3GPP TSG_CN#7
ETSI SMG3 Plenary Meeting #7,
Madrid, Spain
13th – 15th March 2000

NP-000033

Agenda item: 5.2.3
Source: TSG_N WG 2
Title: CRs to 3G Work Item CAMEL phase 2

This document contains “6” CRs on **Work Item CAMEL phase 2**, that have been agreed by **TSG_N WG 2**, and are forwarded to **TSG_N Plenary meeting #7** for approval.

Figure 24a: Procedure CAMEL_MT_GMSC_INIT (sheet 1)

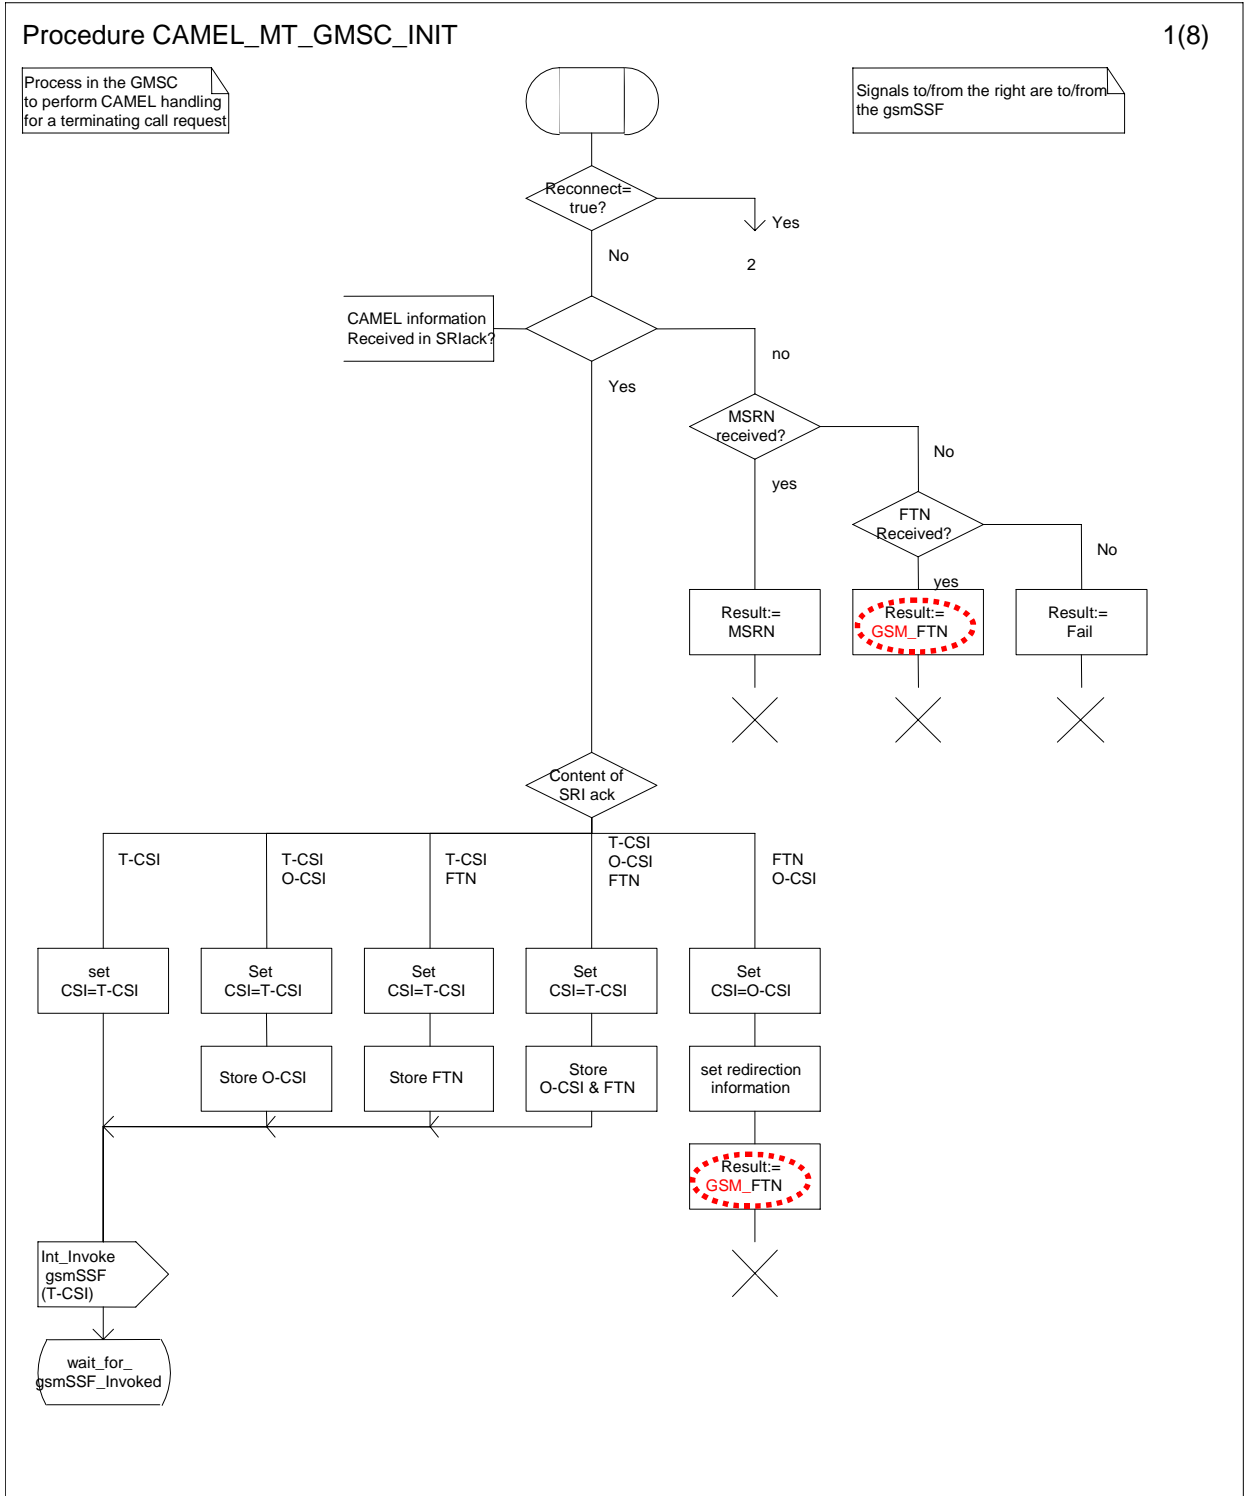
Therefore a new outputs 'CAMEL_FTN' and 'GSM_FTN' are defined in Procedure CAMEL_MT_GMSC_INIT (in GSM TS 03.78). This is to be checked in procedure Obtain_Routing_Address (in GSM TS 03.18). If result = 'CAMEL_FTN' procedure CAMEL_MT_GMSC_Notify_CF (in GSM TS 03.78) shall not be called. CF process shall be started instead.

Figure 33a: Procedure CAMEL_MT_GMSC_Notify_CF (sheet 1)

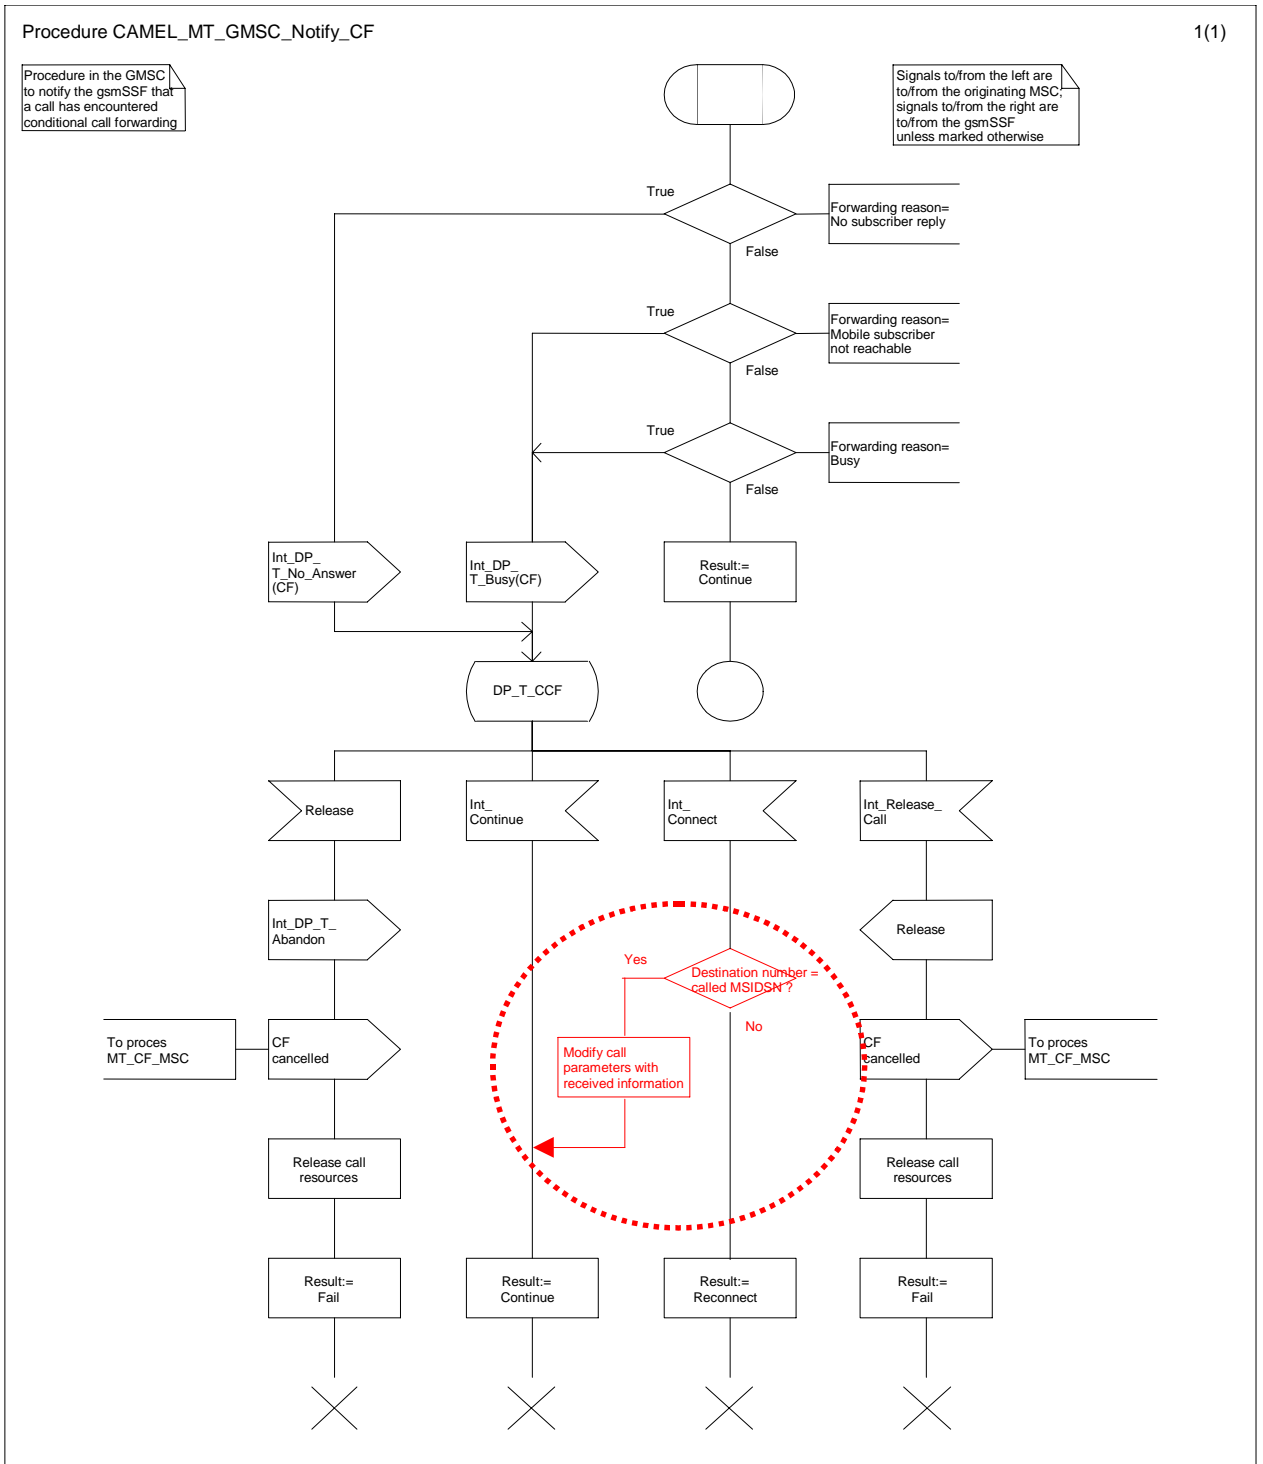
The proposal is to call procedure CAMEL_MT_GMSC_Notify_CF (in GSM TS 03.78) only for GSM-CF, i.e. gsmSCF shall not be notified about new Called Party Number being received from it in CONNECT.

Further, a new check on Called Party Number is proposed in CAMEL_MT_GMSC_Notify_CF procedure. If the same number is delivered in CONNECT then CF process shall be started immediately, i.e. there shall be no Reconnect attempt.

Figure 24a: Procedure CAMEL_MT_GMSC_INIT (sheet 1)

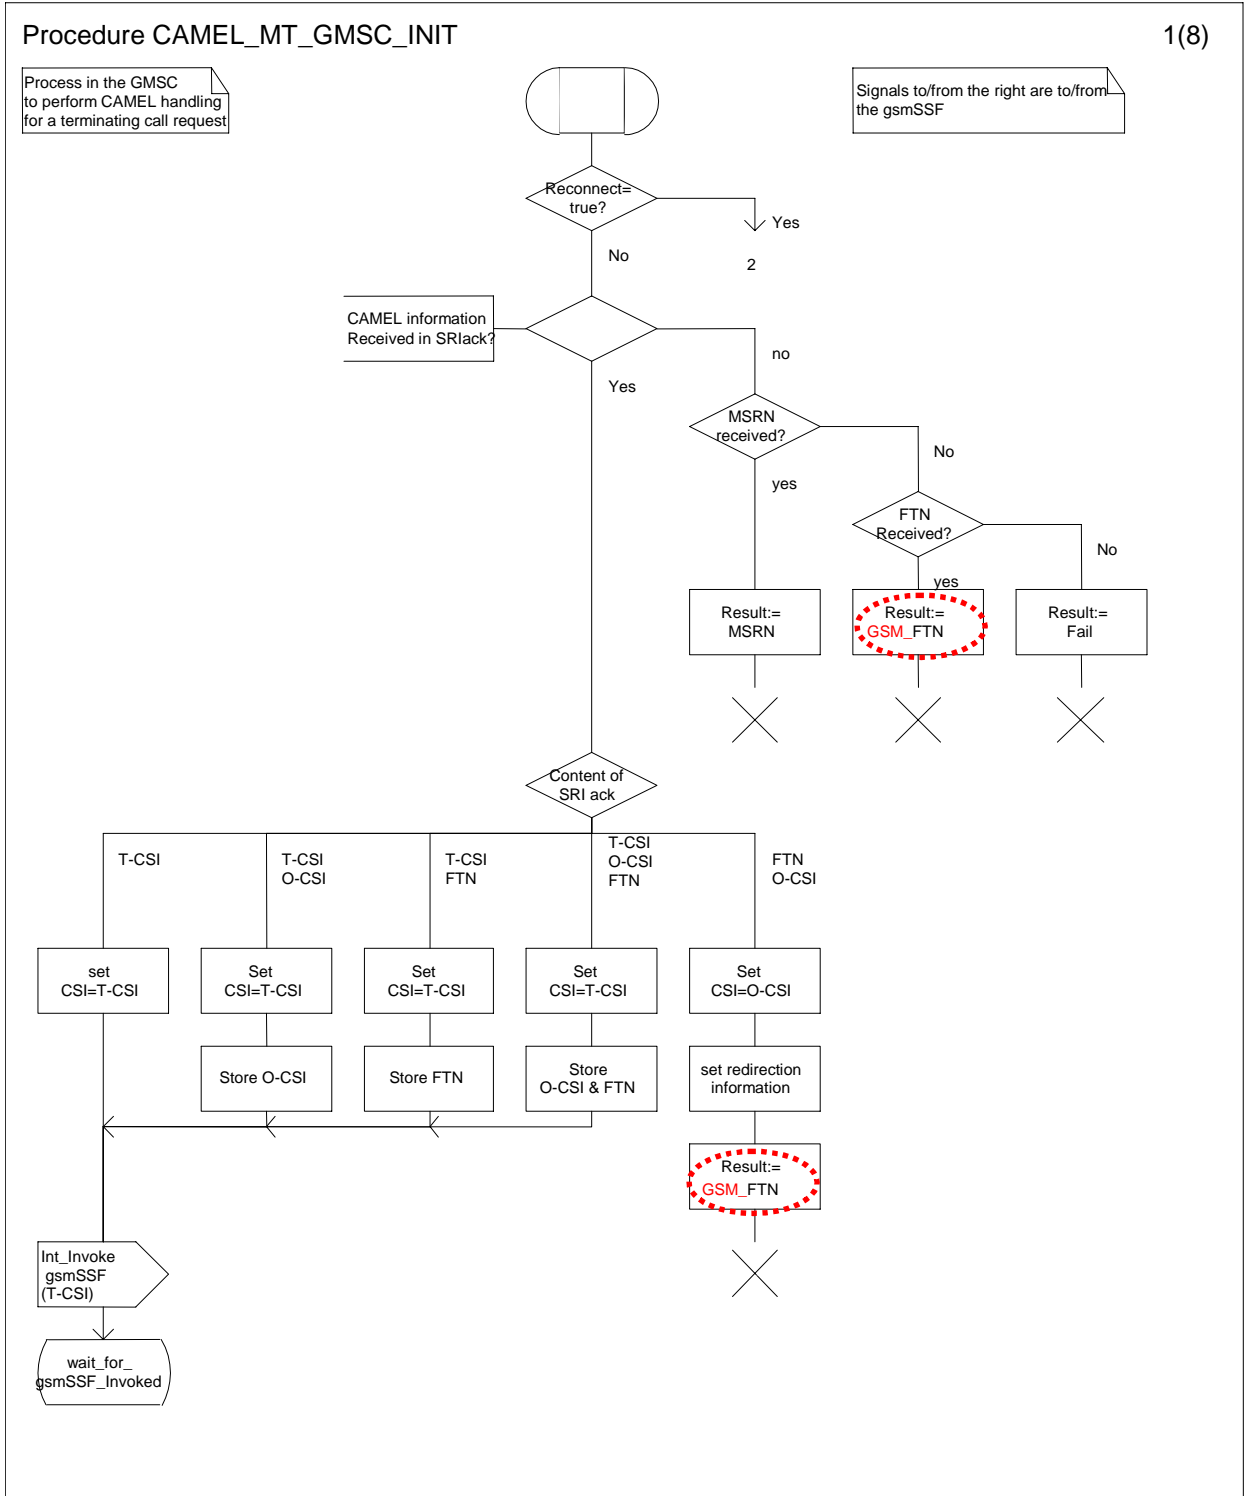
Therefore a new outputs 'CAMEL_FTN' and 'GSM_FTN' are defined in Procedure CAMEL_MT_GMSC_INIT (in GSM TS 03.78). This is to be checked in procedure Obtain_Routing_Address (in GSM TS 03.18). If result = 'CAMEL_FTN' procedure CAMEL_MT_GMSC_Notify_CF (in GSM TS 03.78) shall not be called. CF process shall be started instead.

Figure 33a: Procedure CAMEL_MT_GMSC_Notify_CF (sheet 1)

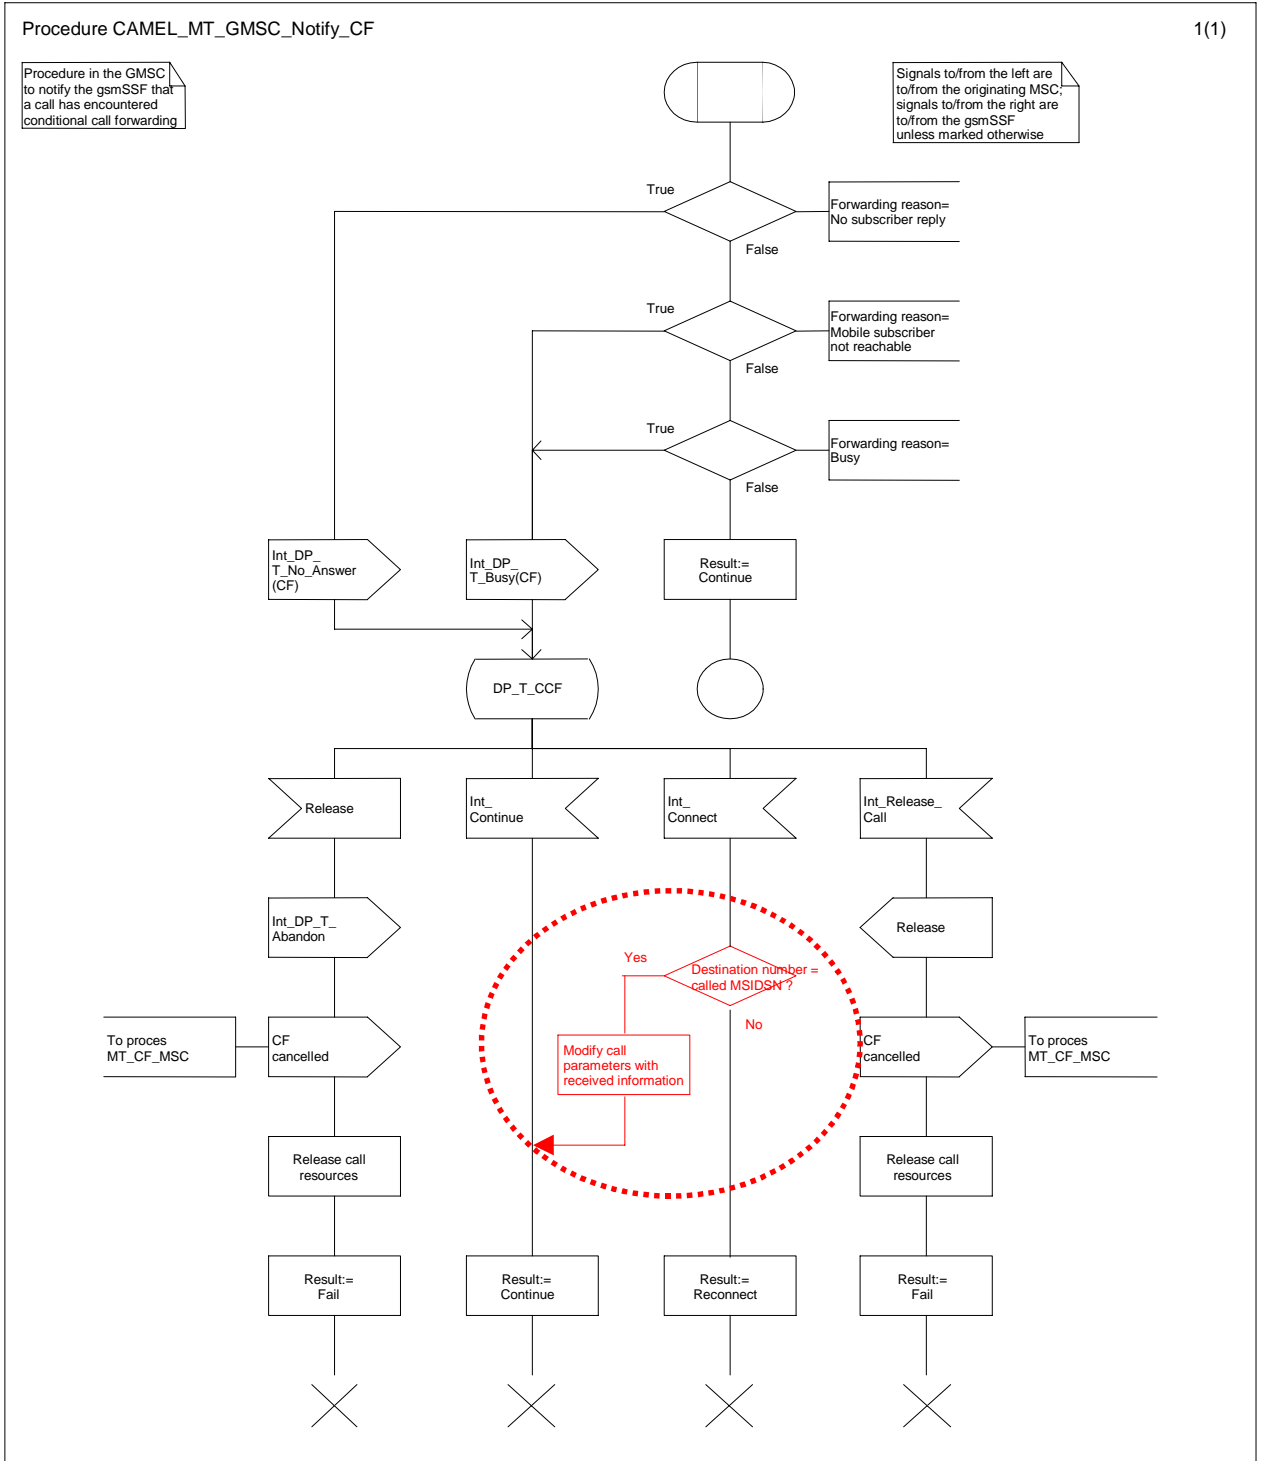
The proposal is to call procedure CAMEL_MT_GMSC_Notify_CF (in GSM TS 03.78) only for GSM-CF, i.e. gsmSCF shall not be notified about new Called Party Number being received from it in CONNECT.

Further, a new check on Called Party Number is proposed in CAMEL_MT_GMSC_Notify_CF procedure. If the same number is delivered in CONNECT then CF process shall be started immediately, i.e. there shall be no Reconnect attempt.

Figure 45n: Process gsmSSF (sheet 15)

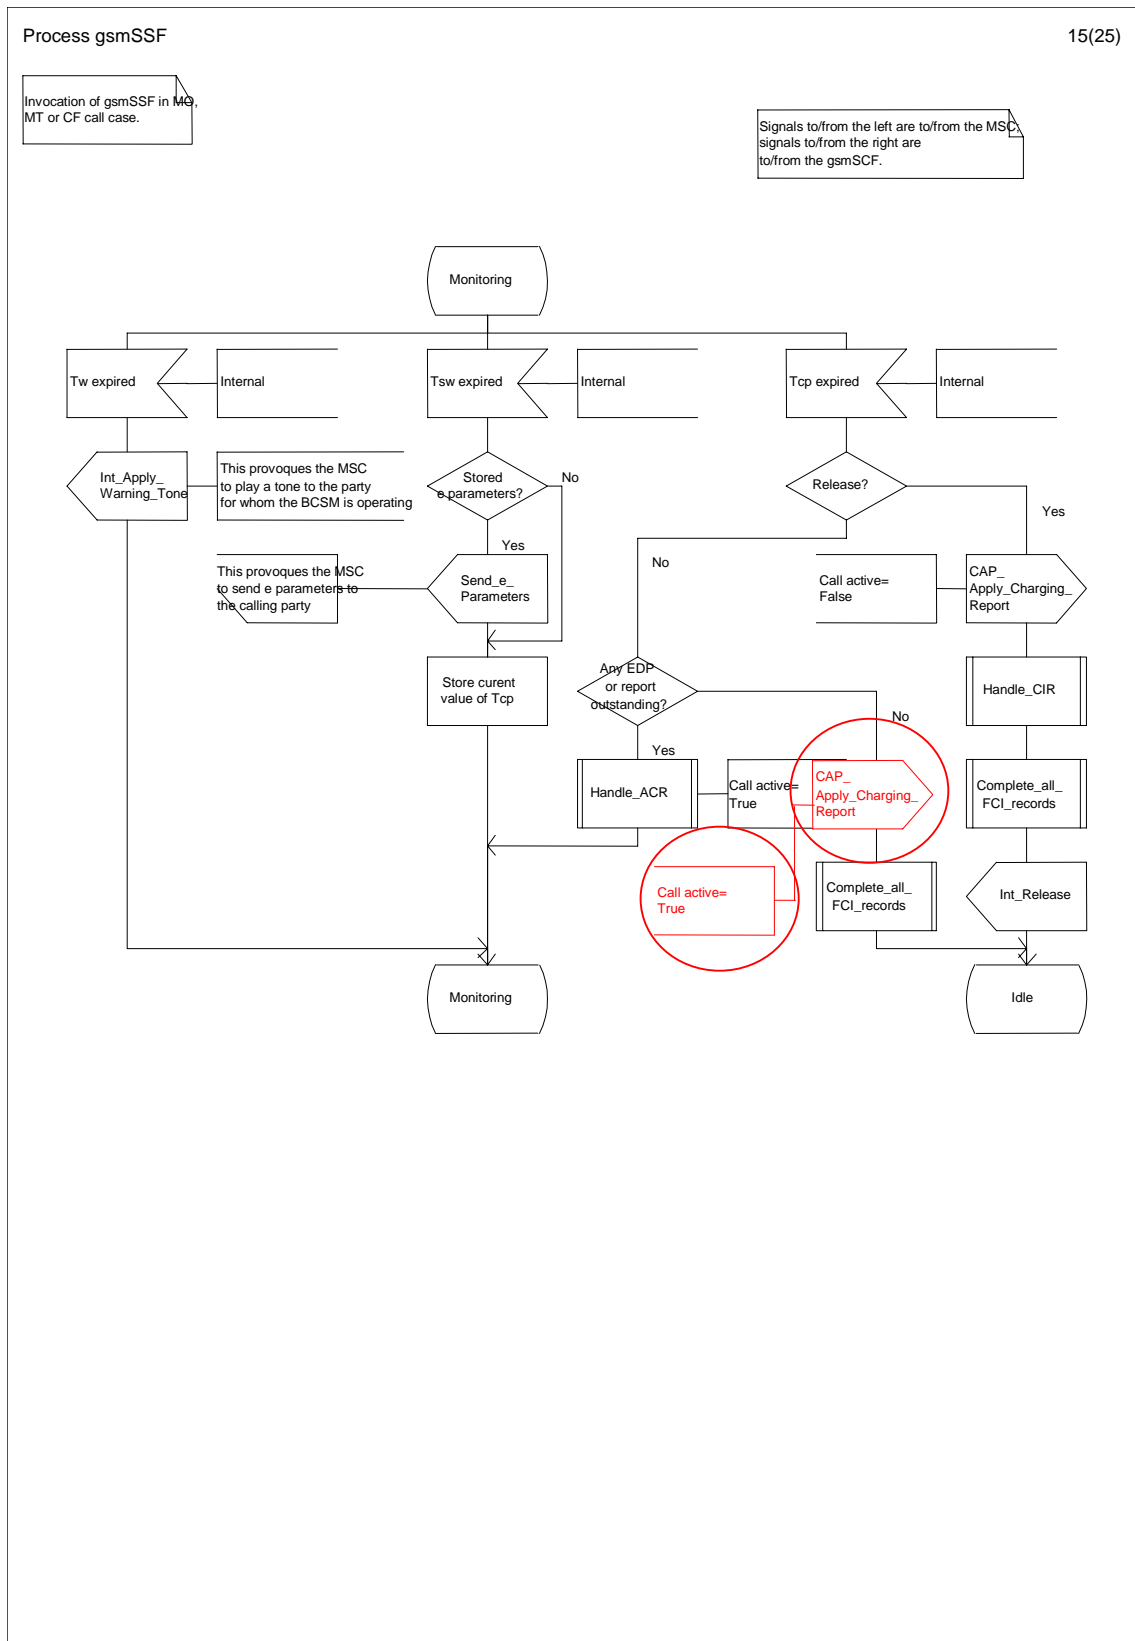
Subject: Correction on gsmSSF SDL; return to idle after ACR

CR 03.78-A105 'Correction on gsmSSF SDL; return to idle after ACR' which was approved at SMG#29 was not correctly implemented. This CR is the correction for the current version.
